Docket Item #12 A-C

DEVELOPMENT SPECIAL USE PERMIT

2006-0031- GLEBE PARK – OLD DOMINION EAST

2006-0030 - GLEBE PARK – WEST GLEBE

Fig. 22: WEST GLEBE – Proposed Site Plan

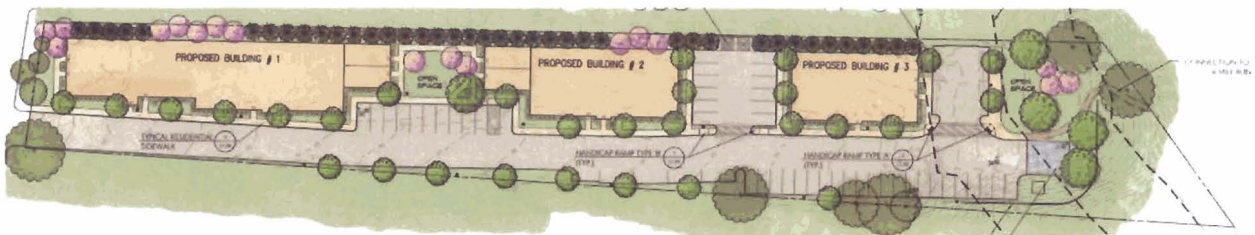
The proposal is to replace the existing 56 ARHA units with 48 new apartments. The new apartments will be located in three separate buildings, with 24, 14 and 10 units respectively. Four townhouse style units are located in the center of the site, surrounding the interior open space courtyard.

The apartments will be owned by ARHA and publicly assisted, so that they are occupied by residents whose incomes are no more than 60% of the average median for the region. The complex will include 134 bedrooms, replacing the existing 114, and will be comprised of 10 one bedroom units; 4 two bedroom units; 20 three bedroom units and 14 four bedroom units. The apartments range in size from 680 sq ft to 1,270 sq ft.

Landscaping is proposed, including street trees, a green setback area along West Glebe Road, ornamental trees along the interior drive aisle and extensive plantings along the Four Mile Run stream bank. Additional amenities, including bike racks, screened transformers and trash receptacles, and the undergrounding of utilities combine to make the new development more attractive, green and conducive to family living as compared to the existing structure and site design.

Fig. 28: WEST GLEBE – Staff Recommended Parking & Open Space Design

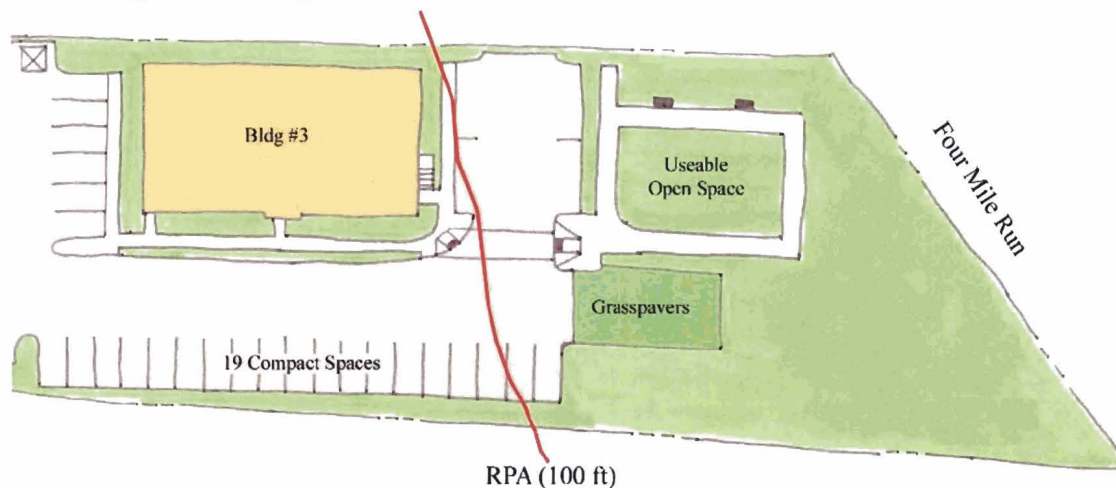
Staff has worked with the applicant to provide as much green space and buffer as possible next to Four Mile Run to ensure the future greenway and trail could be completed as part of future redevelopment of the adjoining sites. Staff has also recommended a public access easement for the area adjacent to Four Mile Run to ensure the potential future use of this property. The applicant has worked with staff to push the building farther away from Four Mile Run however there is still a considerable amount of parking proposed within the Resource Protection Area. Therefore, staff is recommending eliminating some parking spaces from the area adjacent to Four Mile Run to provide additional on-site open space, reduce the size of the proposed retaining wall, and provide a large buffer next to the stream.

The staff recommendation would result in the loss of parking spaces but would provide the additional open space, which staff believes can be justified by the parking study for the public housing units. The recommendation is an attempt to balance the parking demands and the vision of the Four Mile Run Master Plan and bring the proposal into greater compliance with the amount of open space required by the Zoning Ordinance.
